SANTA MONICA MOUNTAINS CONSERVANCY

OLD SMMC LETTER

Comments on Notice of Preparation for Comprehensive Update and Amendment to the Los Angeles County General Plan

AREAS PROPOSED BY SMMC TO BE ADDED

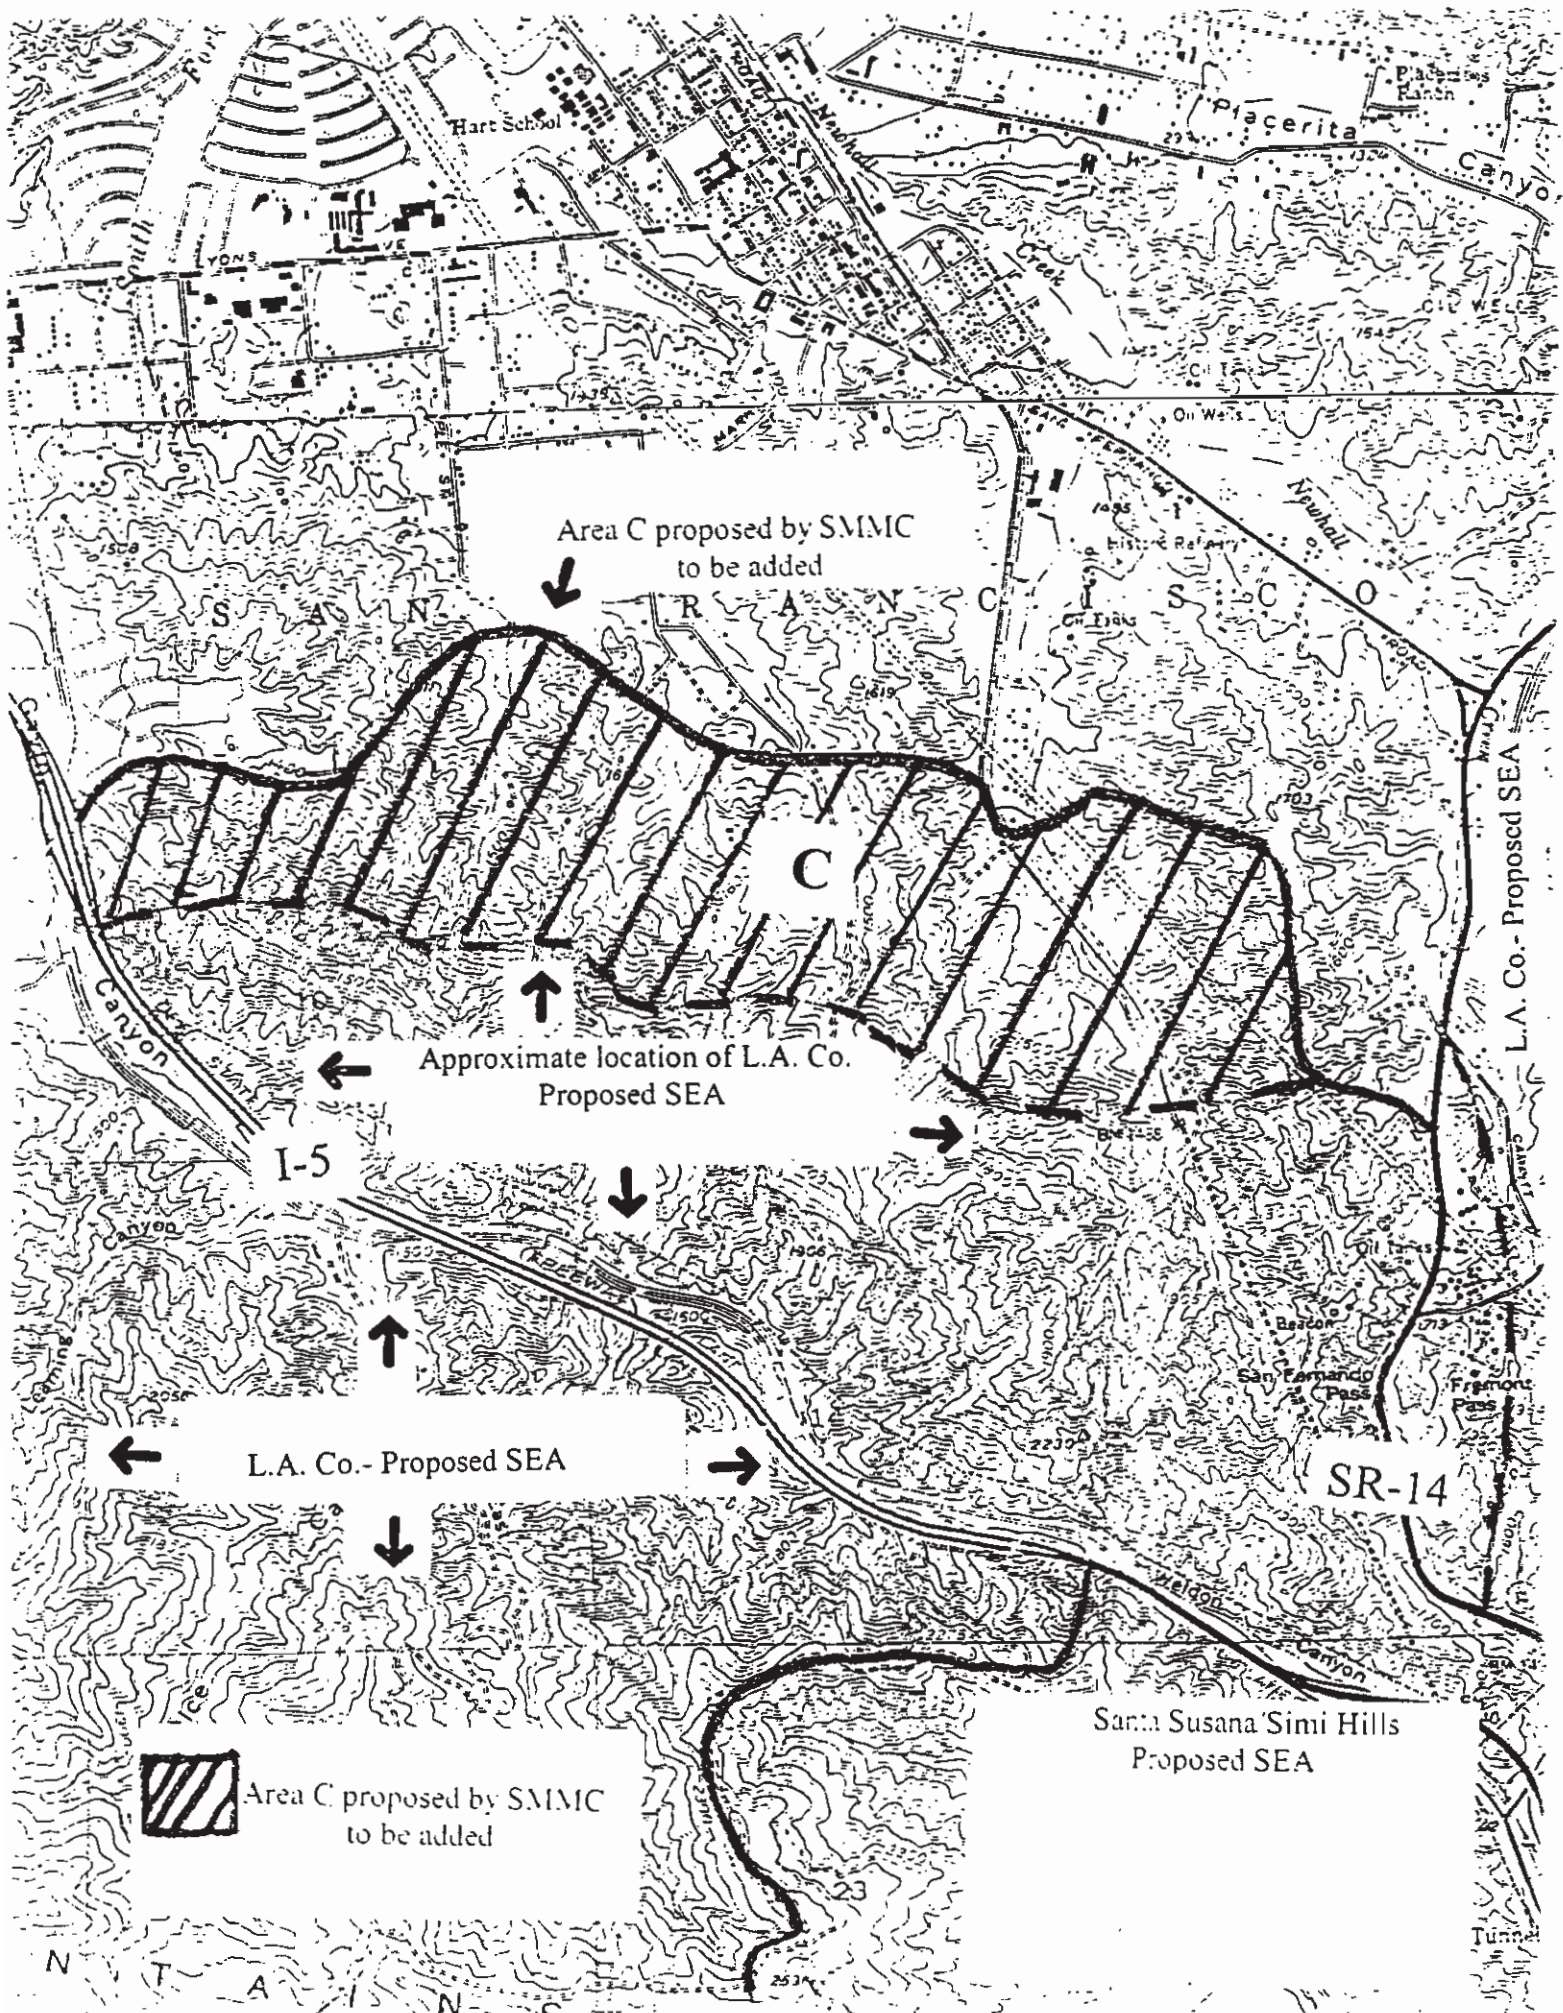
Third, we recommend that Santa Susana Mountains/Simi Hills SEA (or the expanded adjacent Santa Clara River SEA) be further expanded to include a critical area of the triangular habitat area north of the intersection of the north of the SR 14 and I-5 intersection (see Area C on the enclosed figures). This area is identified as a "Missing Linkage"¹ and preservation of the biological function of this area is essential to maintain connectivity between San Gabriel Mountains and Santa Susana Mountains. This triangle of land also contains high quality oak woodland and big-cone douglas fir.

Fourth, Santa Susana Mountains/Simi Hills SEA boundary should reflect a connection between existing SEA 64 (west of, and adjacent to I5, including the Westridge Open Space), and the remainder of the Santa Susana Mountains/Simi Hills proposed SEA (see Area D on

the enclosed figures). These areas are currently ecologically connected, and there appears to be no biological justification to representing them as isolated areas. (In the November 2000 Update Study, the SEA boundaries reflected these areas as connected.) The Conservancy prefers to depict the connection partially through the existing private open space on the developed Stevenson Ranch property, and partially through the Stevenson Ranch Phase V property (not yet built).

Potential Open Space Connections in the NE Santa Susana Mtns

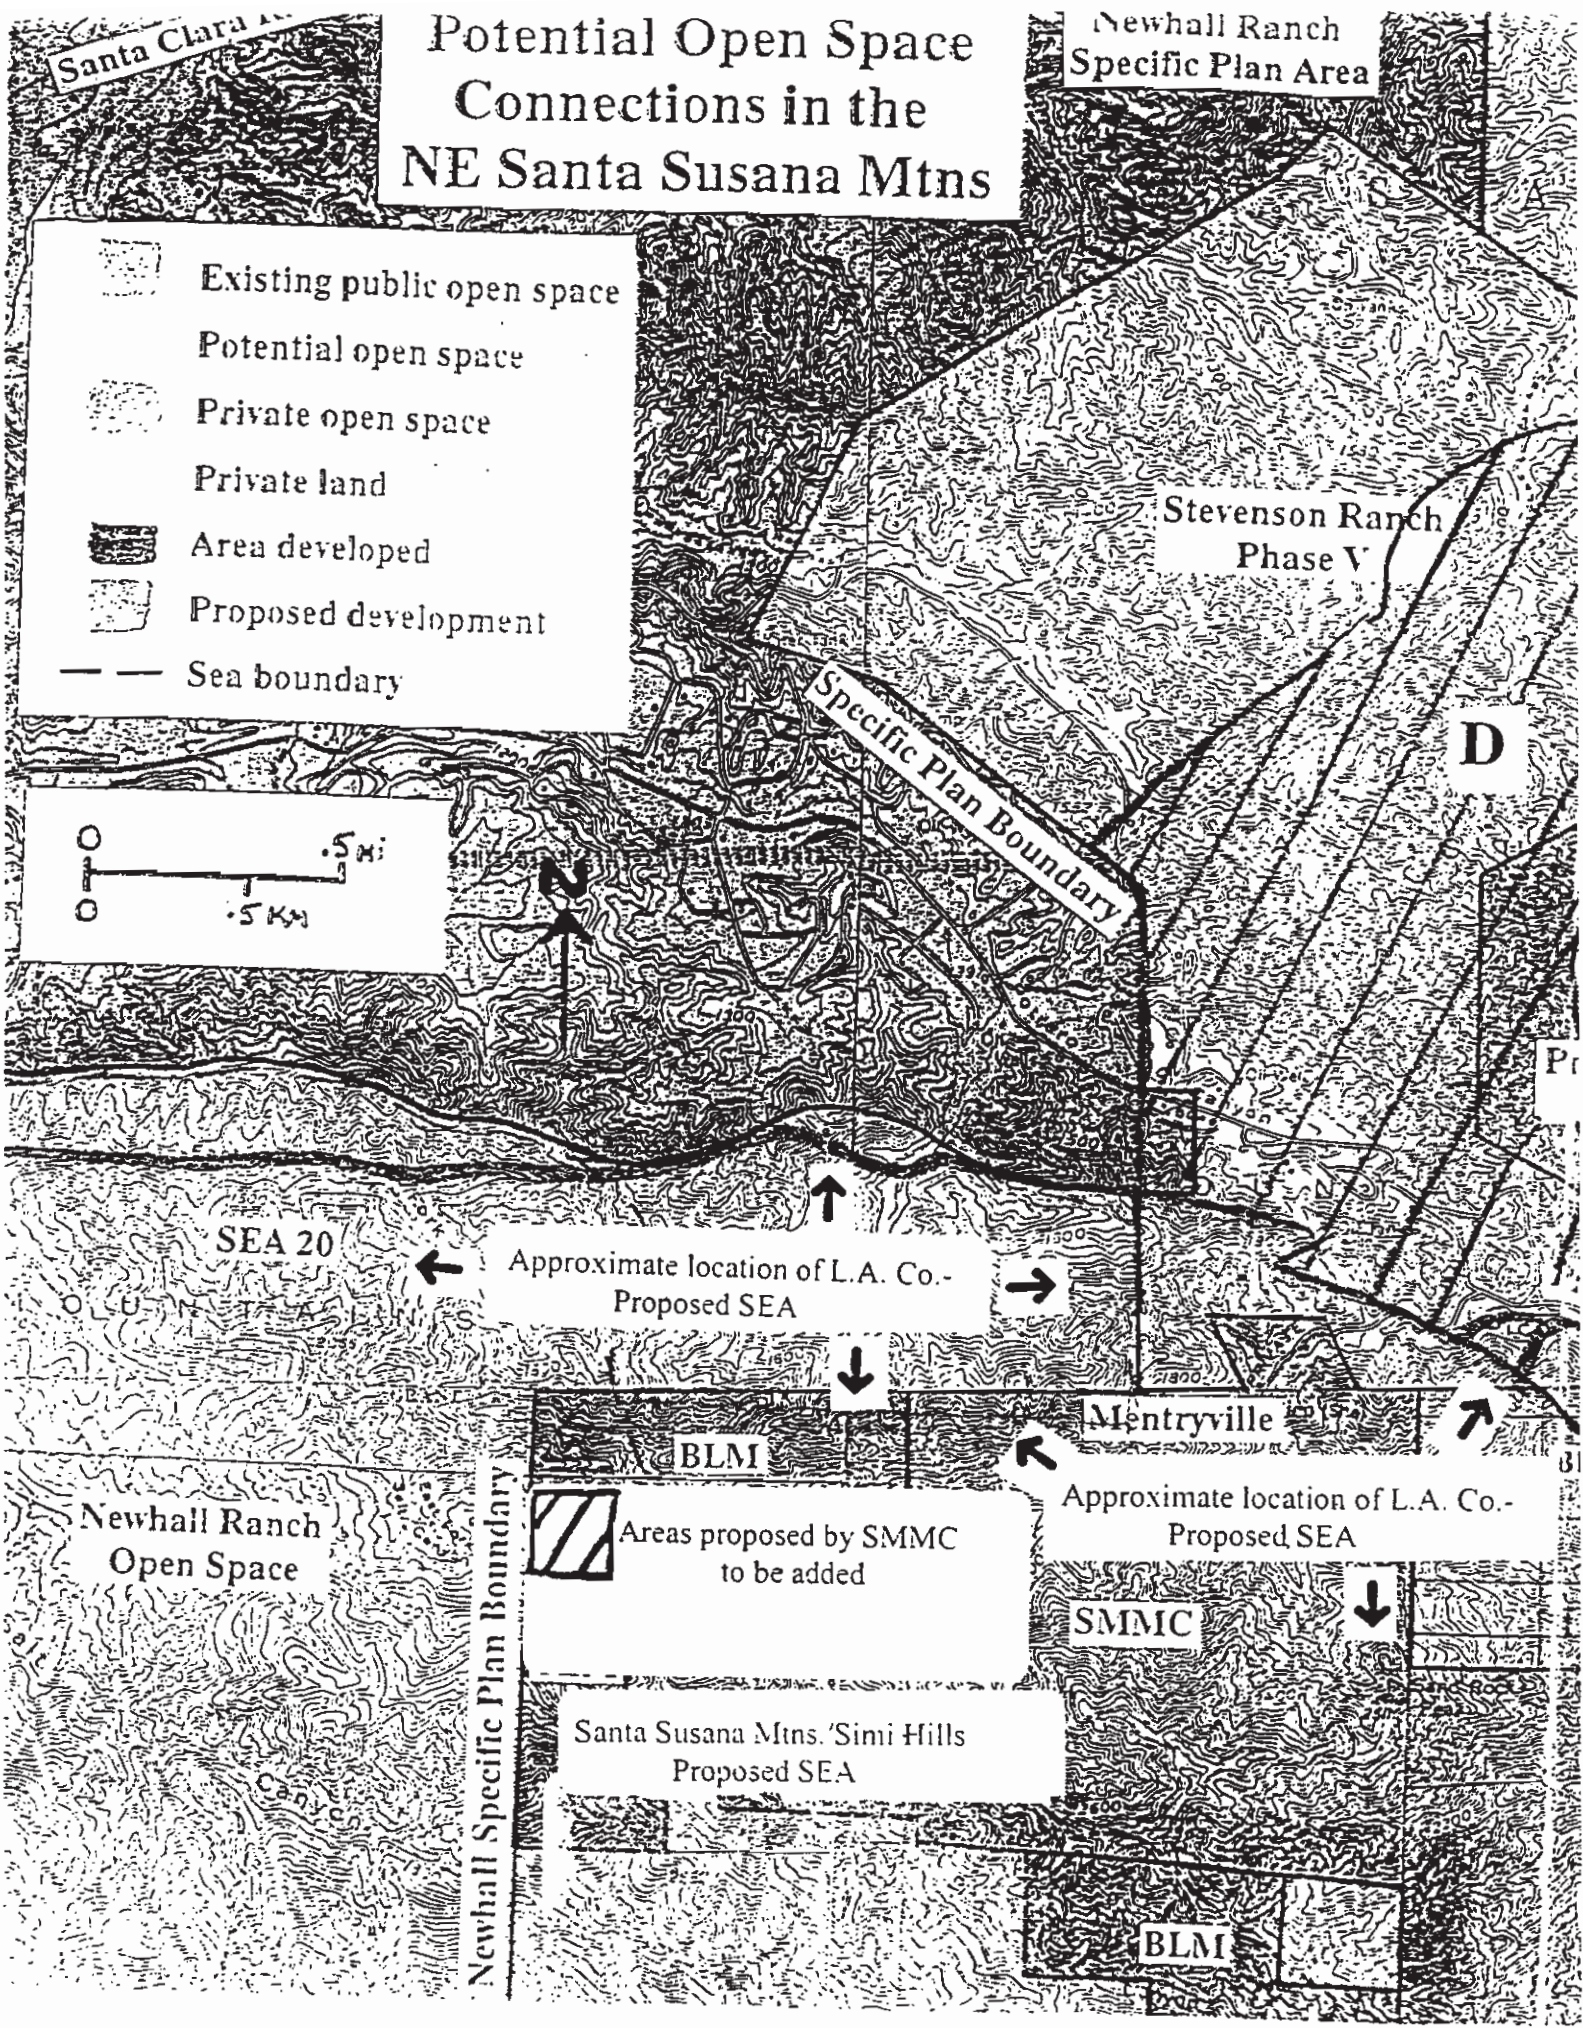
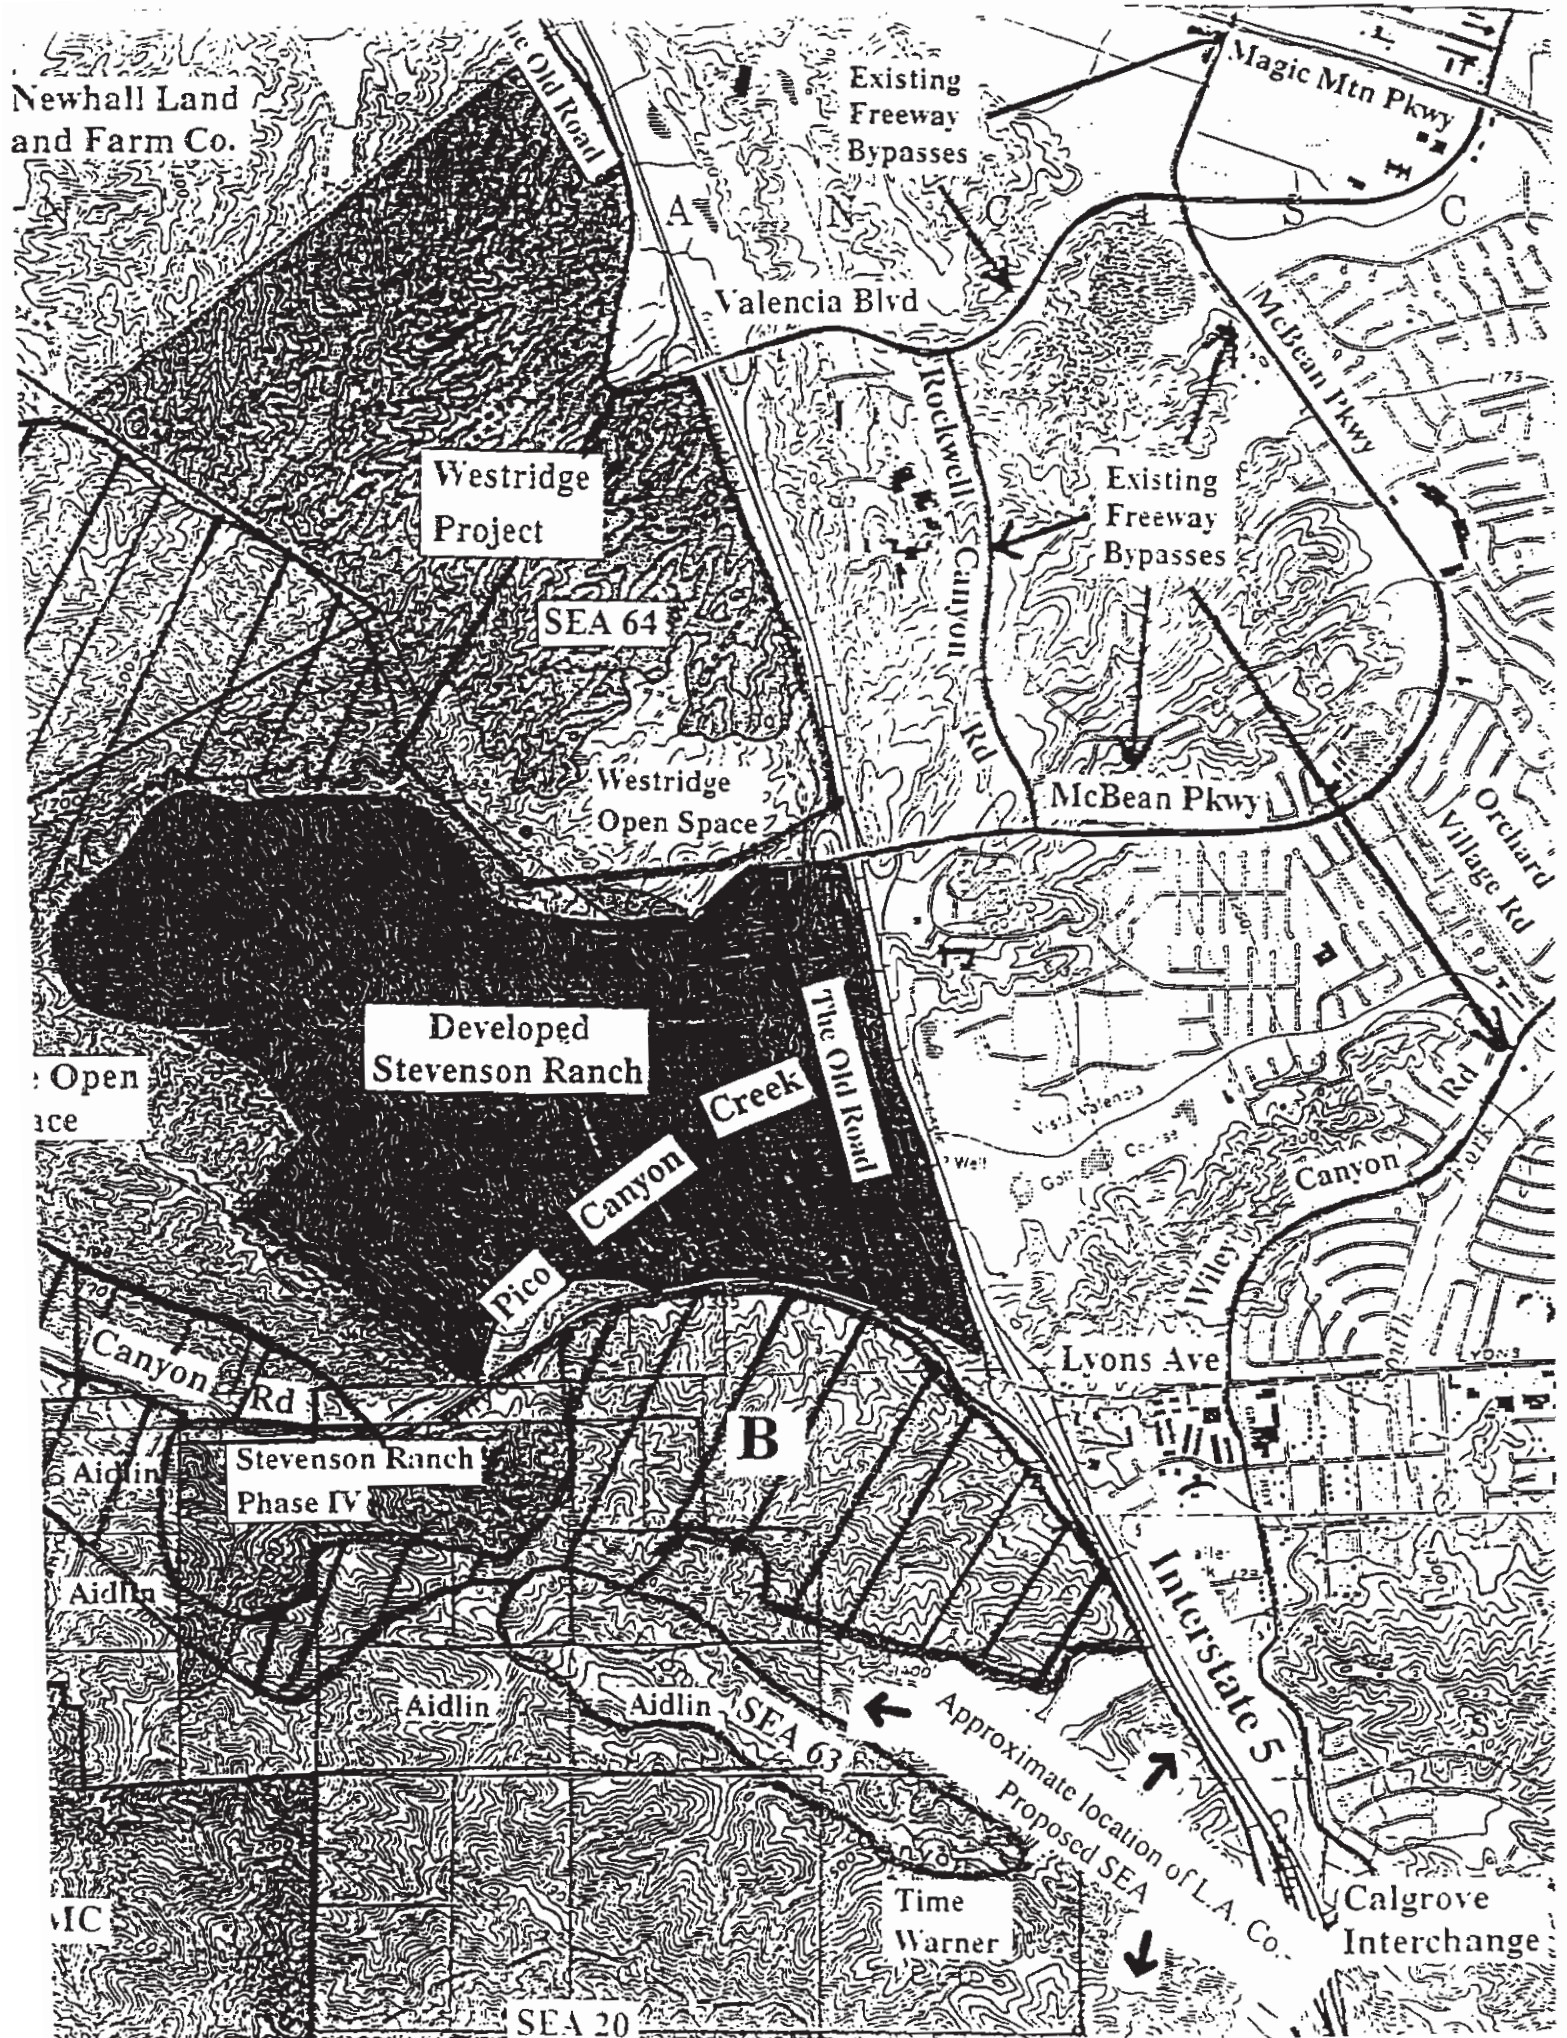
First, Santa Susana Mountains/Simi Hills SEA should be expanded to incorporate all of our proposed Area A (see April 30, 2001 letter), effectively including Browns and Mormon Canyon. Browns and Mormon Canyons are biologically critical components of the eastern Santa Susana Mountains ecosystem. Although the exact location of the proposed SEA boundary in this area is difficult to determine based on the scale of Figure 4, it appears that only part, or only the west side, of Mormon Canyon is proposed to be included in this SEA. All but a short section of Mormon Canyon is undeveloped, contributing to the ecological value of this canyon. Mormon Canyon is part of the Santa Susana Mountains ecosystem, and there appears to be no justification why half of the canyon would be cut out of this SEA. The entire canyon, including both sides of the canyon, and appropriate buffer (as shown in our proposed Area A) must be included in this SEA.

Second, Santa Susana Mountains/Simi Hills SEA should be expanded to incorporate all of our proposed Area B (see April 30, 2001 letter). The SEA should include all of the undeveloped area south of Pico Canyon, to the Old Road, up to the SEA boundary proposed in the IS. This area is ecologically important due to the presence of core wildlife habitat and high quality oak woodlands.
